Product Change Notification / LIAL-13ERYV184

CCB 4198.001 Final Notice: Qualification of ASSH as a new assembly site for selected 24xx01, 24xx02, 24xx04, 24xx08 and 24xx16 device families available in 8L TSSOP package.

CCB 4198.001
Pre and Post Change Summary
PCN #: LIAL-13ERYV184

Pre change

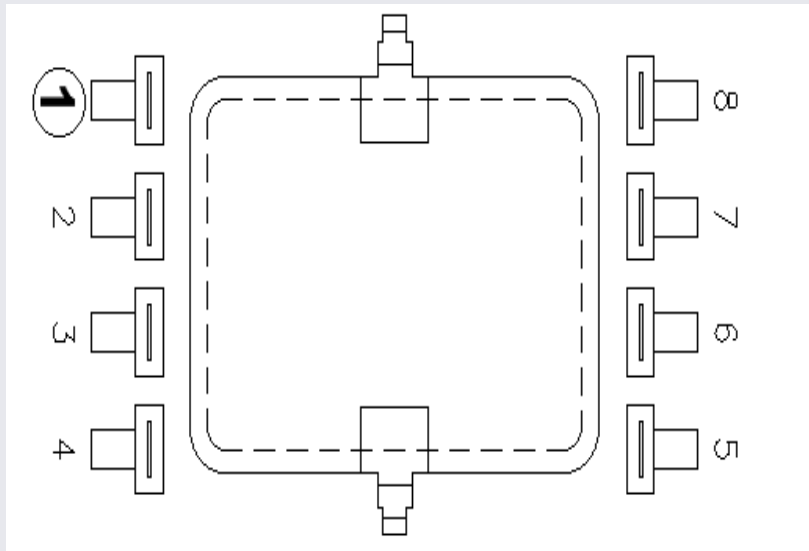
Lead frame lead-lock

No

Post Change

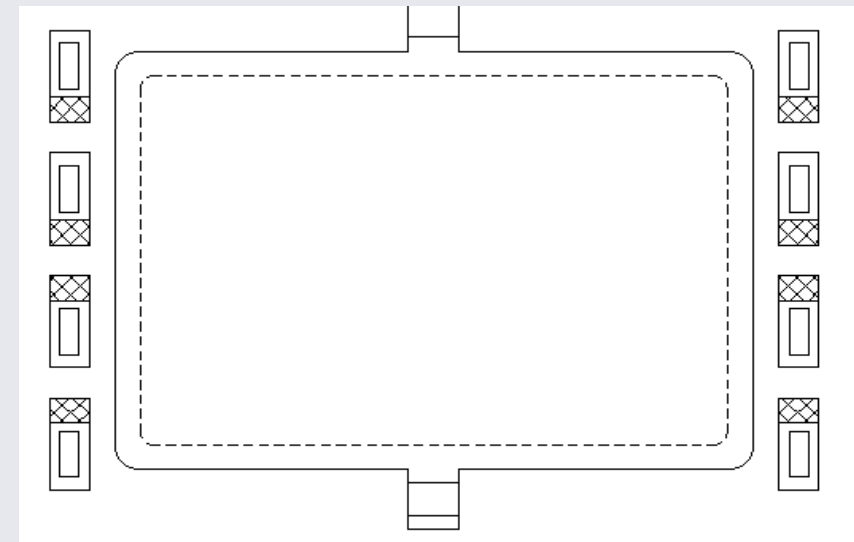
Lead frame lead-lock

Yes
